ZION STATION UNITS 1 AND 2

OFFSITE DOSE CALCULATION MANUAL

## Errata to Offsite Dose Calculation Manual (Feb. 1979)

Figure 1.1  
Flow Chart for Off-site Dose Calculations

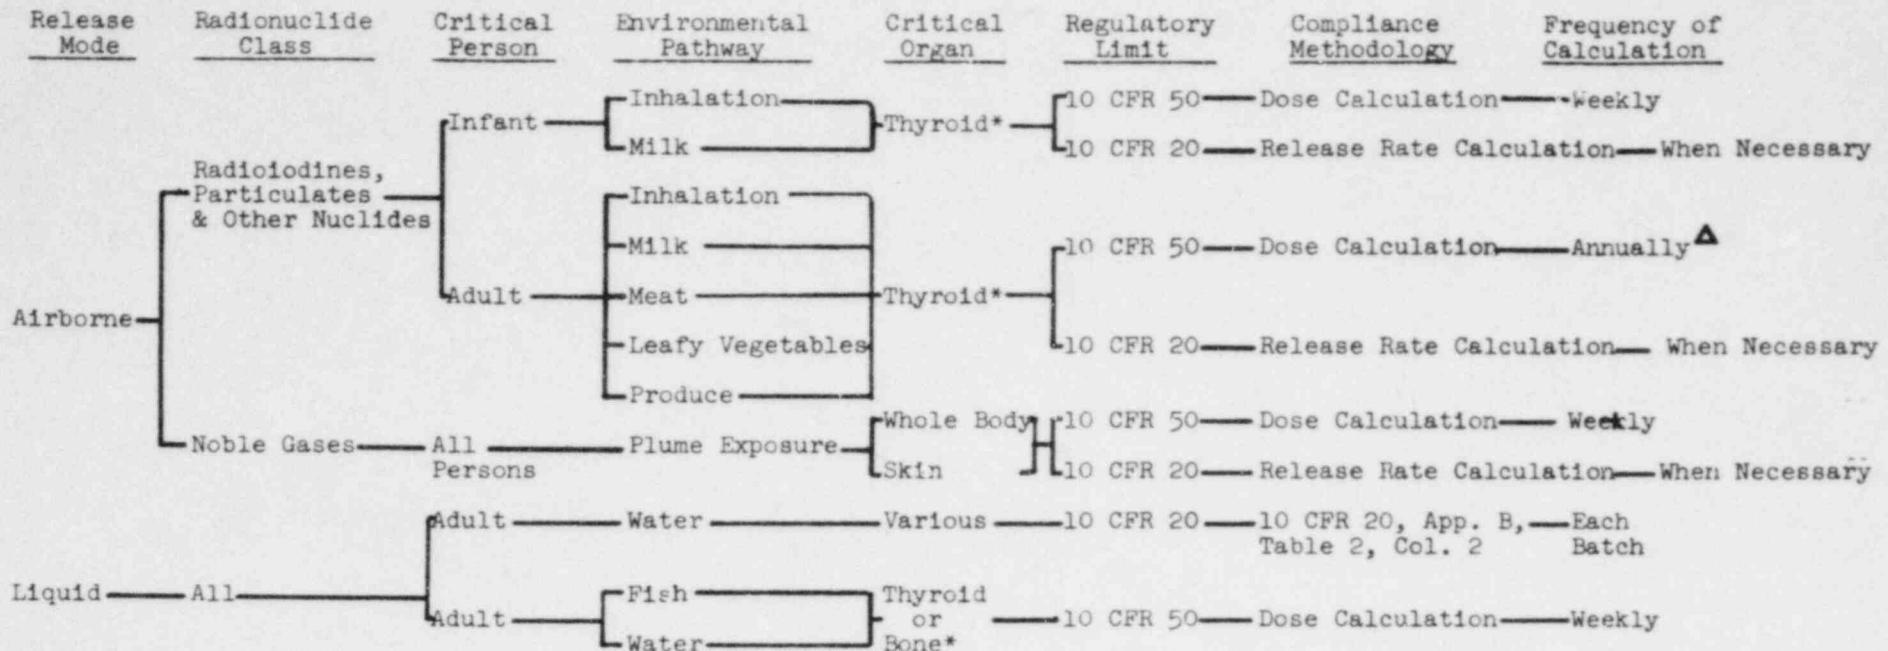
<u>Page</u>	<u>Section</u>	<u>Correction</u>
1.0-2	Figure 1.1	Under "Frequency of Calculation" change the three entries labeled "weekly" to "monthly".
2.1-10		Under "(D/Q)s" change Subsection 3.2.2.3 to 3.2.3.3.
2.1-11		Under "(D/Q)v" change Subsection 3.2.2.3 to 3.2.3.3.
2.1-11		Under "(D/Q)g" change Subsection 3.2.2.3 to 3.2.3.3.
2.2-4		Change the symbol "t" to "tw, tf"
3.2-8	3.2.3.3	In the next to last paragraph change "... Appendix 7.1 and Figure 7.1-5 to 7.1-8." to "... Appendix 7.1 as Figures 7.1-5 to 7.1-8."
5.1-1	5.1.1	In the first paragraph, 8th line, change "... calculate the doses weekly, ..." to "... calculate the doses monthly, ..."
5.2-1	5.2.2	In the first paragraph under 5.2.2 change "The concentrations of non-noble gas ..." to "The concentration of non-noble gas ..."
-	Table 7.1-10	Replace the given table with the following table and footnote.
